*Superconducting Super Collider Laboratory
2550 Beckleymeade Avenue, Suite 240
Dallas, TX 75237-3946*

MEMORANDUM

Subject: BNL-FNAL CDM Compatibility

FIGURE 1

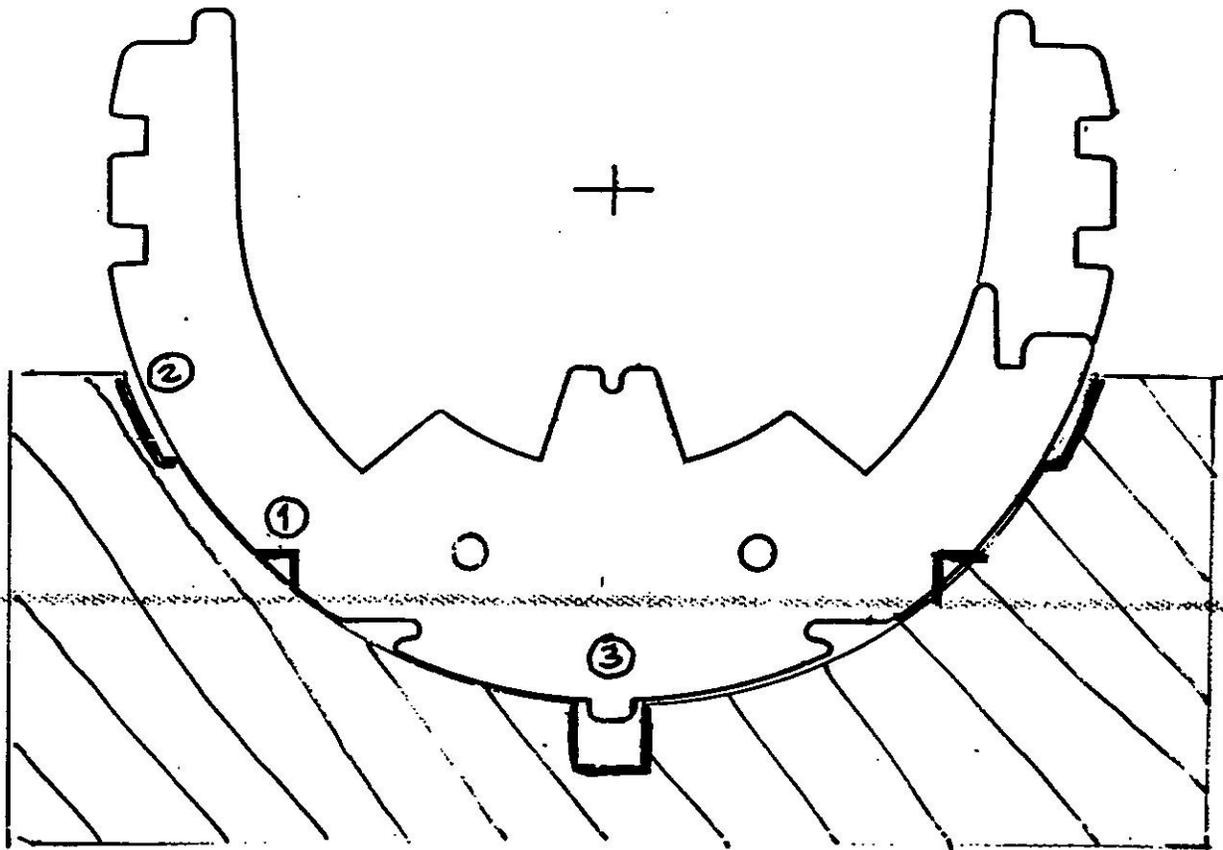
1. Collaring: The first two 50mm long magnets are planned to be collared at BNL on the new production type collaring press. After that, any subsequent magnets required for the string test could also be collared the same way with industrial participation. It was felt there is some compromise to the design if the BNL collars were to be altered to fit the FNAL collaring tooling (See Figure 1). Thus, it was recommended that FNAL proceed to obtain dies for the upper and lower collaring press laminations that would exactly match the BNL collar. The laminations would be made into tooling sections which could be assembled into the FNAL press frame to permit collaring of the BNL design collar. (Phil Sanger will look into the question of the die procurement.)

BNL COLLAR INTO FINAL PRESS.OBSTACLES

- ① INTERFERENCE OF ALIGNMENT TABS.
- ② CUTOUT FOR FINAL COLLAR REDUCES LATERAL SUPPORT OF BNL COLLAR ; COULD CAUSE YIELDING AT ASSY.
- ③ PRECISE ALIGNMENT REQUIRED AT VERTICAL TAB OF BNL COLLAR MUST BE ACHIEVED BY CUSTOM FITTING INSERT INTO LOOSELY TOLERANCED (± 0.010) KEYWAY.
